71-9029

Reference Docket Number 71-9029

TITLE MODEL 676 PROJECTOR

SIZE A DWG. NO. R 67690

SIZE	DWG. NO.	R 67690	REV
A	SCALE:	NONE	D
		SHEET 2 OF 5

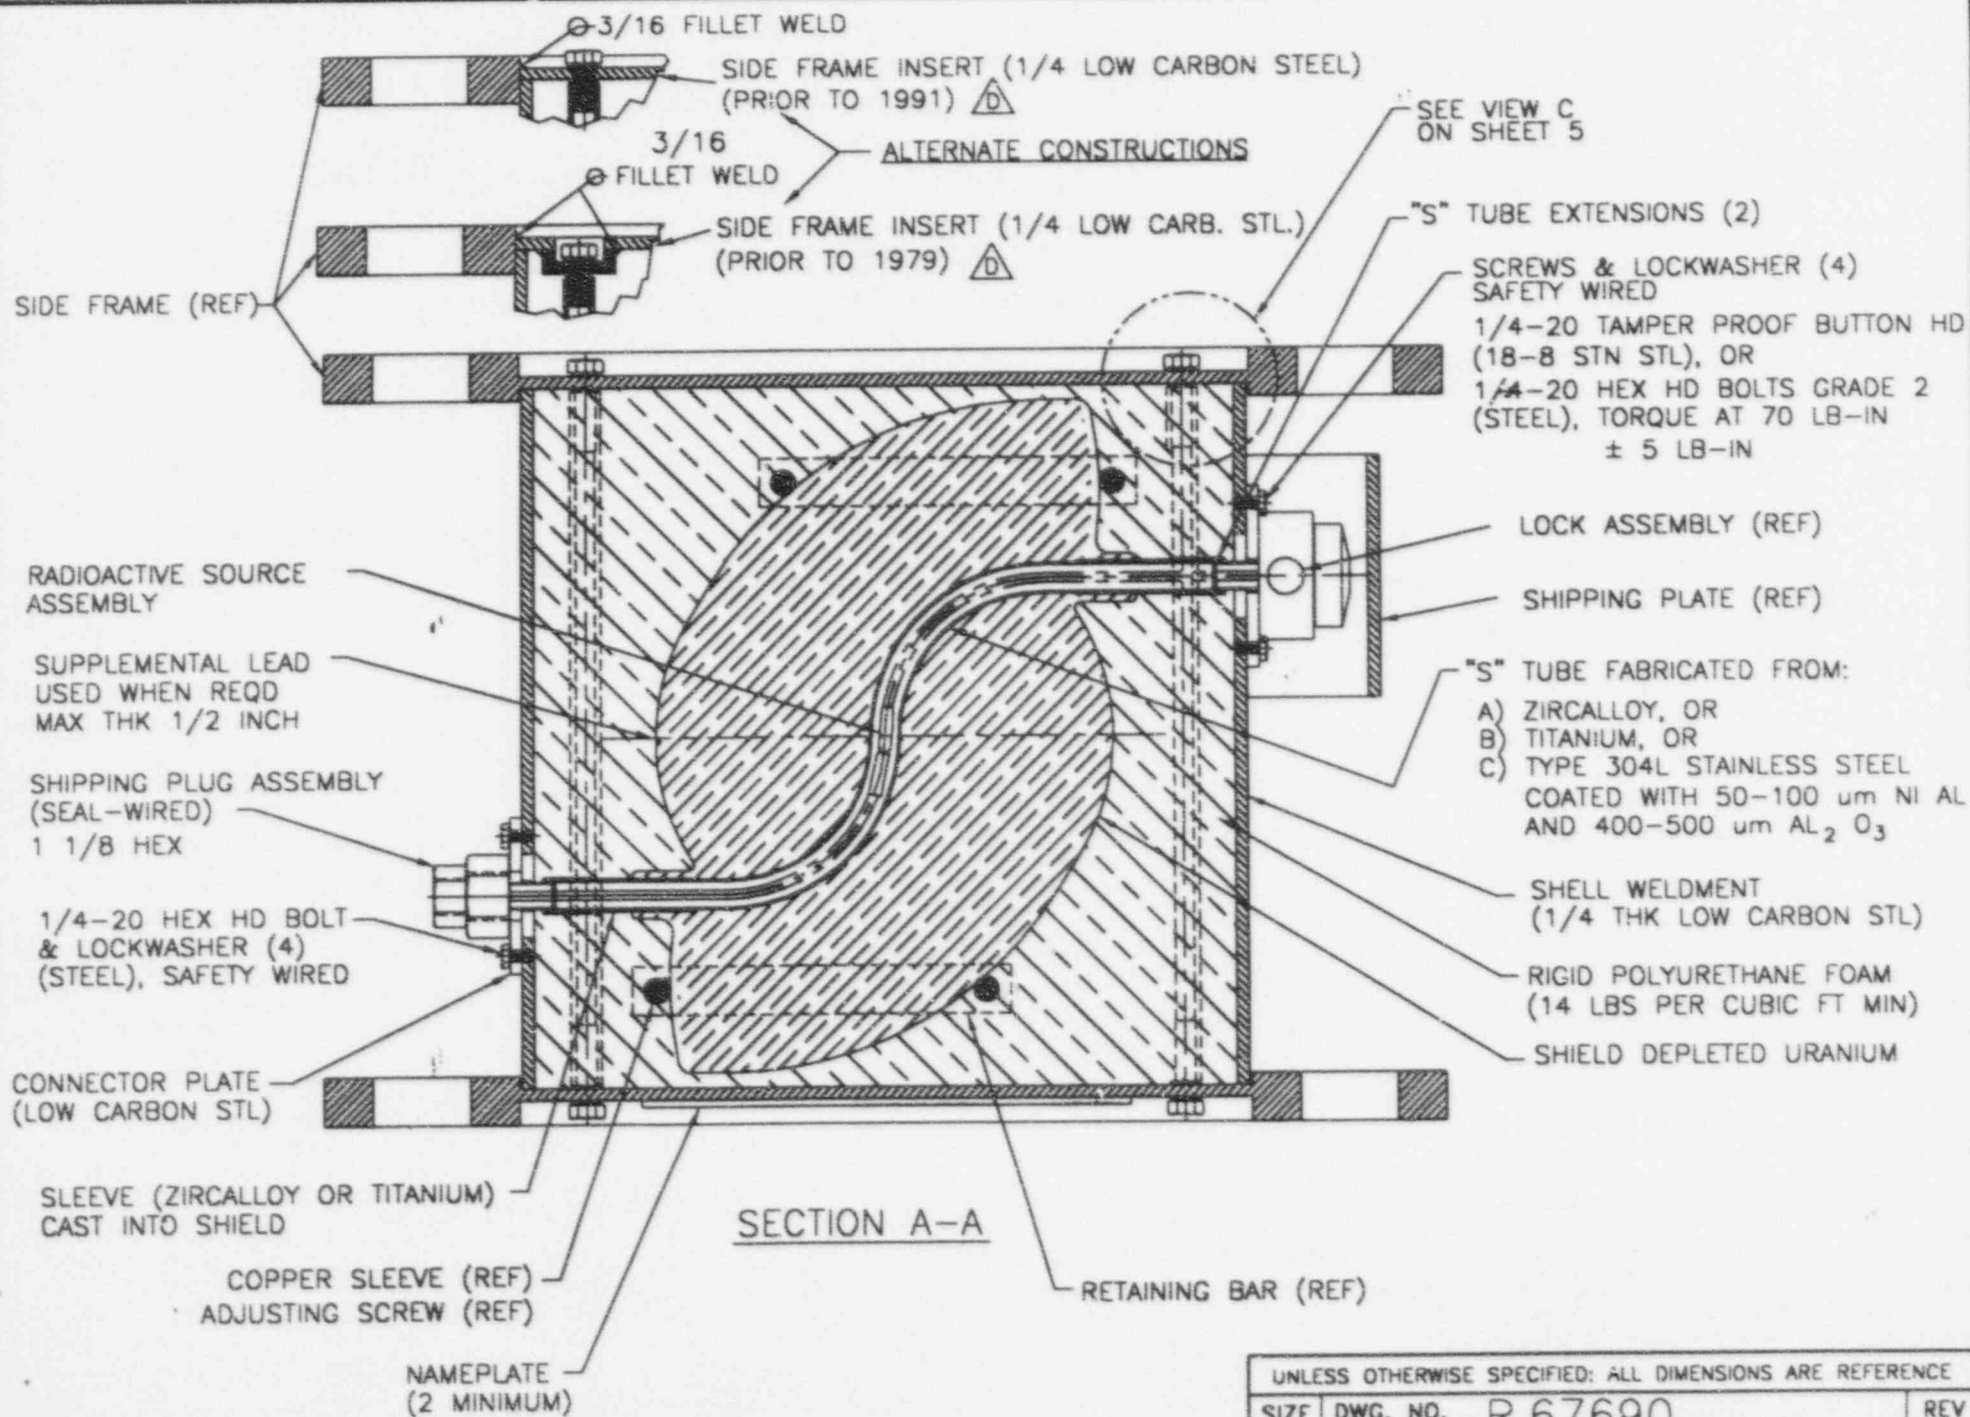
CLARIFIED DATES ON SHT. 2 DCR #656  
ADDED ASME CODE REF. ON SHT. 5
